The paper presents a very good characterization of a very heavy rainfall event in Mallorca. Despite this is an isolated event, this a very good example on how analyzing this type of hazards from the meteorological origin, to the derived impacts of the flood. Such chain of analyses can serve as example to analyze a very common hazard affecting to many Mediterranean sites. The used methodology is robust and the authors provide evidence that it worked in a very reasonable way (despite the difficulty to get reliable observations for calibration and validation under such extreme conditions). The graphical material provided in the article is of great quality.

We kindly appreciated the reviewer opinion on our manuscript. Following we describe how we addressed the main changes suggested by the reviewer. For a better tracking of the corrections, note that our answers are shown in normal font and reviewer comments are shown in bold.

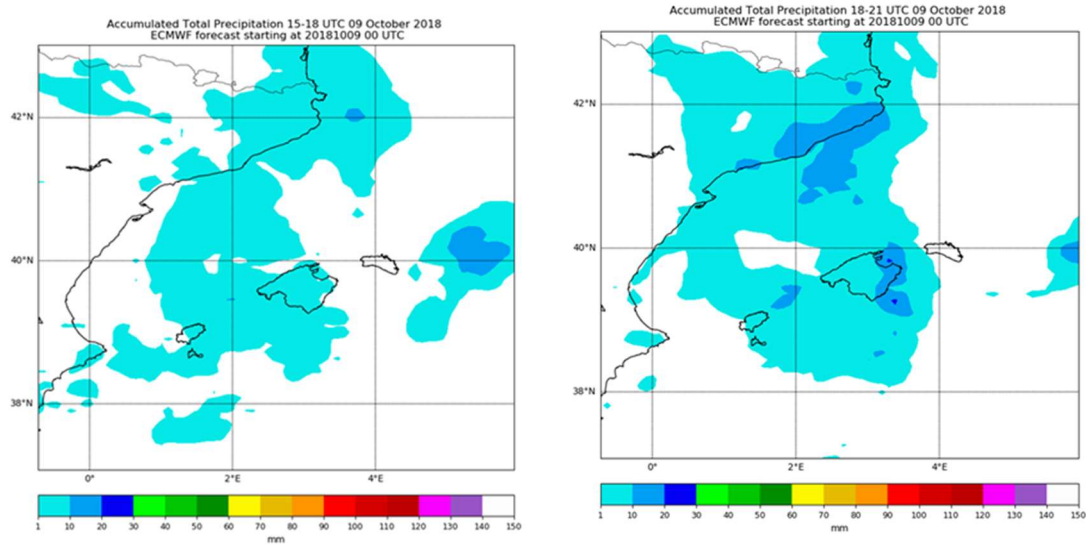
Authors said that models clearly underestimated the event, but it could be good to see more on that to illustrate to which extent the early warning systems (not real time ones) may work in these areas.

The beginning of section 2.3 has been extended in order to provide further details on the severe underforecast of this event by the official operational models. In particular, we mention the systematic underestimations by all cycles of ECMWF and HARMONIE-AROME. As a graphical example, we show below the deterministic ECMWF forecast rainfall at 3-h intervals provided by the cycle starting at 9 October 00 UTC. We believe adding this kind of figures in the manuscript is unnecessary given the hydrologic-hydraulic main orientation of the study.
